1. AGENCY USE ONLY (Leave blank)		2. REPORT DATE 04/00/90		3. REPORT TYPE AND DATES COVERED	
4. TITLE AND SUBTITLE FINAL DECISION DOCUMENT FOR THE INTERIM RESPONSE ACTION AT THE COMPLEX DISPOSAL TRENCHES, ROCKY MOUNTAIN ARSENAL, VERSION 4.0				5. FUNDING NUMBERS

**FINAL DECISION DOCUMENT
FOR THE INTERIM RESPONSE ACTION
AT THE
COMPLEX DISPOSAL TRENCHES
ROCKY MOUNTAIN ARSENAL
APRIL 1990
CONTRACT NO. DAAA15-88-D-0022/0002
VERSION 4.0**

RESPONSE TO COMMENTS FROM THE EPA
ON THE PROPOSED DECISION DOCUMENT FOR THE INTERIM RESPONSE ACTION
FOR THE ARMY COMPLEX DISPOSAL TRENCHES

RESPONSE TO COMMENTS FROM SHELL OIL COMPANY
ON THE PROPOSED DECISION DOCUMENT FOR THE INTERIM RESPONSE ACTION
FOR THE ARMY COMPLEX DISPOSAL TRENCHES

Figure 2-2

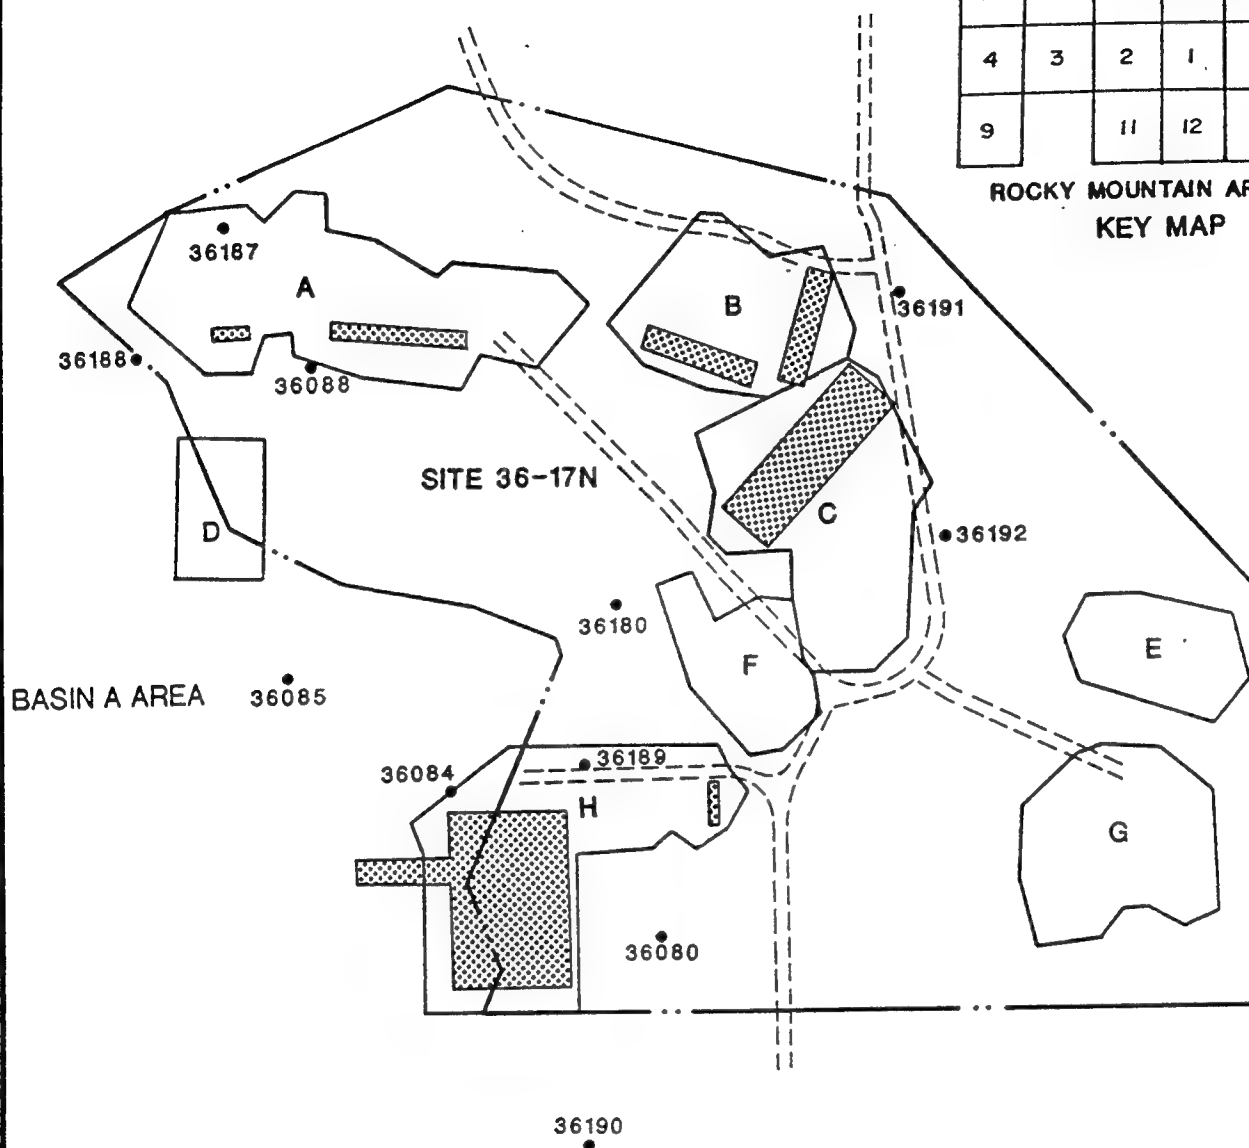
Comment 4: The shaded areas of Figure 2-2 need to be darkened or crosshatched to stand out clearly.

Comment 3: p. 2-4 Figure 2-2 - Location of Trenches in Site 36-17N - This figure appears to be generally lacking in information. Groundwater contamination data for the listed wells are not included, and a number of groundwater monitoring well locations (such as 36090, 36121, 36158, 36184, and 36185) are also omitted. Figure 2-2, or additional figures, should contain such data.

Response: The figure has been revised.

Response: Figure 2-3 has been added to show monitoring well locations. Appendix B was added to the Draft Final Decision Document and includes soil and groundwater contamination data.
